PASSENGER SEAT BELT WARNING WITHOUT PASSENGER

Bulletin No.: 08-003/21

APPLICABLE MODEL(S)/VINS

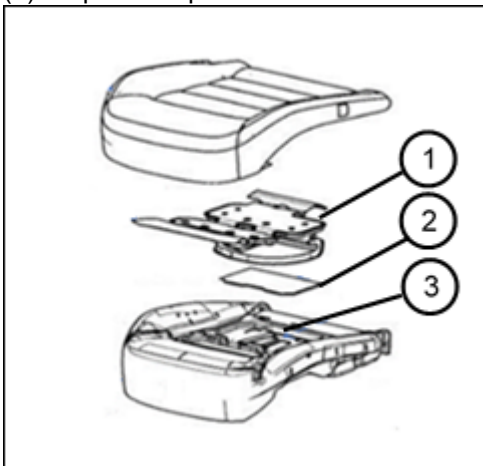
Some vehicles equipped with a seat ventilation system may have the passenger seat belt warning light on, even though there is no passenger in the seat. This concern may be caused by an overly sensitive detection of the occupancy sensor. The weight of the seat ventilation unit may be captured by the occupancy sensor, resulting in a false detection.

To eliminate this concern, the construction of the pad (2) has been changed so that the weight of the seat ventilation unit (1) is spread to parts other than the occupancy sensor (3).

1. Verify the customer concern.
2. Replace the passenger side front seat cushion with a modified one according to MGSS online FRONT SEAT CUSHION TRIM REMOVAL/INSTALLATION.
3. Verify the repair.
